**ADDRESS: 2108 SANSOM ST**

Proposal: Construct rooftop addition

Review Requested: Review In Concept

**OVERVIEW:** This in-concept application proposes constructing a rooftop addition on a two-story former carriage house that is classified as contributing to the Rittenhouse Fidler Historic District.

# BUILDING SECTION

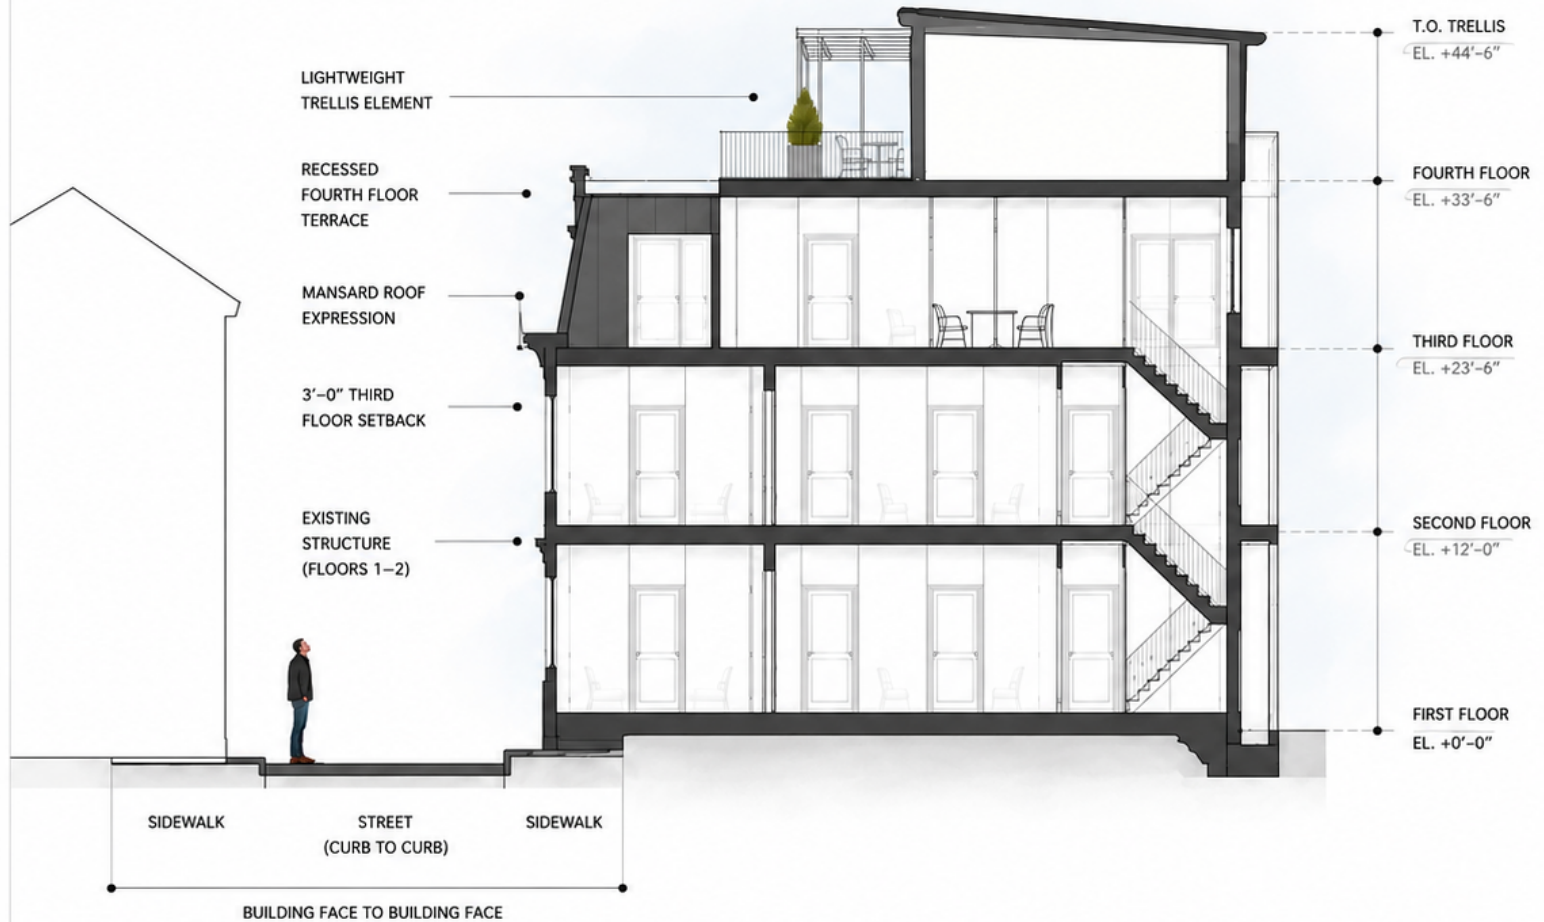
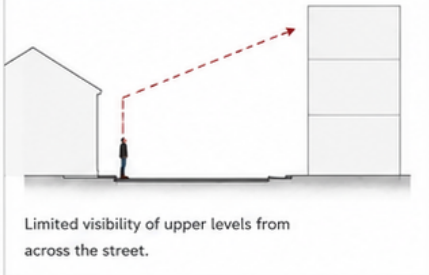
The application includes preliminary floor plans and a section drawing showing a mansard roof treatment at the third-floor level and a partial fourth floor with a roof deck set back from the front elevation.

- *Roofs Guideline: Not Recommended: Changing the configuration or shape of a roof by adding highly visible new features (such as dormer windows, vents, skylights, or a penthouse)*
  - The third floor of the addition as proposed would be highly visible and, depending on the setback of the fourth-floor elements, they may also be visible from Sansom Street. A visibility study should be included with a future application for final approval.
- *Standard 3: Each property will be recognized as a physical record of its time, place and use. Changes that create a false sense of historical development, such as adding conjectural features or elements from other historic properties, will not be undertaken.*

- The use of a mansard roof may create a false sense of historical development that does not reflect the true history of the building.
- *Standard 9: New additions, exterior alterations, or related new construction shall not destroy historic materials that characterize the property. The new work shall be differentiated from the old and shall be compatible with the massing, size, scale, and architectural features to protect the historic integrity of the property and its environment.*
  - The section drawing suggests the height of the proposed third floor is in scale with the existing buildings, but the quality of the other images makes this compatibility difficult to fully evaluate.
